PHAP14-00025

ITEM #1

Certificate of Appropriateness for the removal of the windows on the rear addition and infilling the masonry openings with concrete and stucco

WINDOW DETAIL

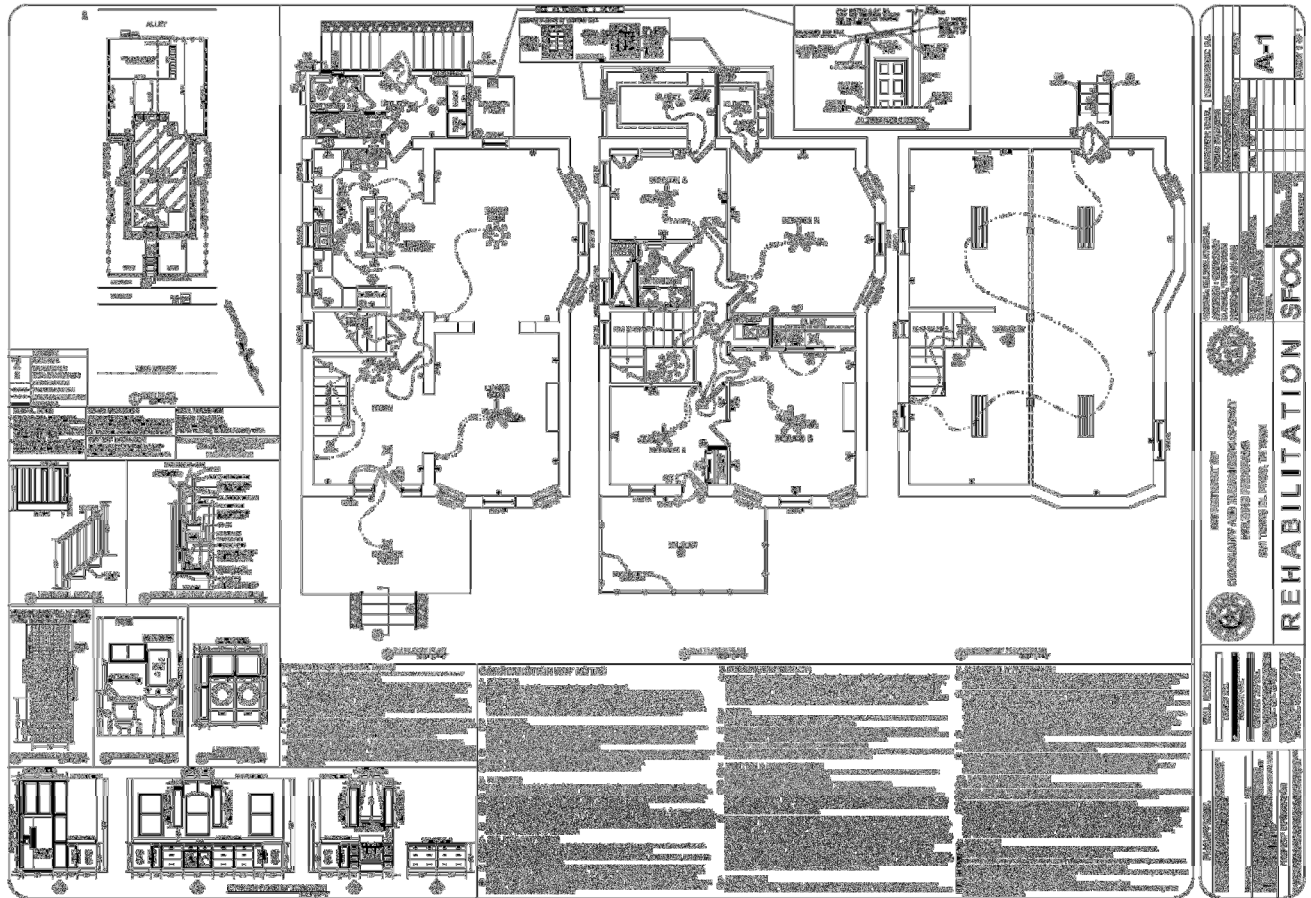
The modification is that the window openings be filled in but not covered with stucco so that the fenestration pattern remains visible.
